Division of Reclamation,
Mining and Safety

PERMIT INFORMATION

Permit Number: C-1996-084 Mine Name: Lorencito Canyon Mine Operator: New Elk Coal Company, LLC Operator Address: 12250 Highway 12 Weston, CO 81091	County: Las Animas Operation Type: Surface Permit Status: Suspended Ownership: Private
	Operator Representative Present: None
Operator Representative Signature: (Field Issuance Only)

Inspection Start Date: May 20, 2025 Inspection Start Time: 15:20 Inspection End Date: May 20, 2025 Inspection End Time: 16:38	Inspection Type: Coal Partial Inspection Inspection Reason: Normal I&E Program Weather: Clear
Joint Inspection Agency: None	Joint Inspection Contacts:
Post Inspection Agency: None	Post Inspection Contacts:
Inspector(s): Amber M. Gibson	Inspector's Signature:  Signature Date: June 3, 2025

FIGURE 1. AREAS WHERE RILLS, GULLIES AND SPARSE VEGETATION HAS BEEN FOUND TO BE A PERSISTENT PROBLEM AT THE SITE ARE WITHIN THE DOTTED CIRCLE AREAS. BACKGROUND IMAGE IS THE 2020 ANNUAL REPORT MAP.

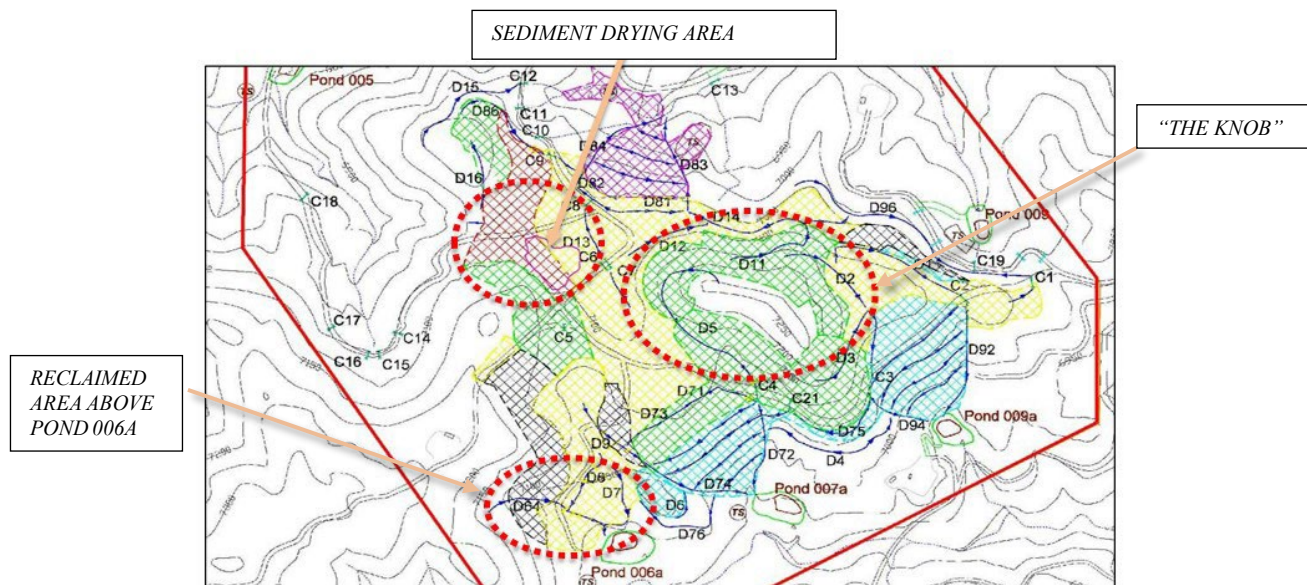
4. The following items pertain to ongoing erosional issues in the areas shown in Figure 1, that pursuant to Rule 4.14.6 need to be addressed. A Technical Revision will be required to expand on the current Rill and Gully plan in the PAP. **The Operator shall submit the technical revision, obtain approval, repair the erosion, and stabilize the slopes pursuant to the approved plan.**
